# San Diego County Water Authority

September 22, 2010

Re: 2010 Integrated Resources Plan Update

**ATTACHMENT 2 – COMMENTS ON MWD’S JULY DRAFT 2010 IRP UPDATE****WATER RATE IMPACTS**

Figure A

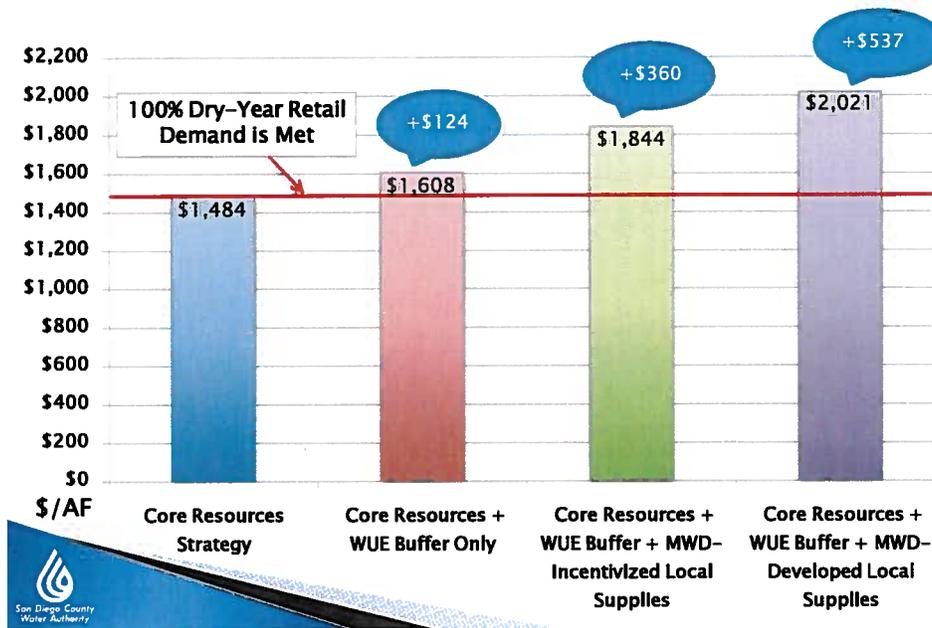
The development of the Buffer Supplies would lead to a similar outcome. If these supplies are not needed – and the draft indicates that demands for the Buffer Supplies will not exist – then the costs to develop them are truly in excess of need and stranded and, therefore, will be stranded costs. A graphic illustration of the stranded costs is shown below in Figure A.
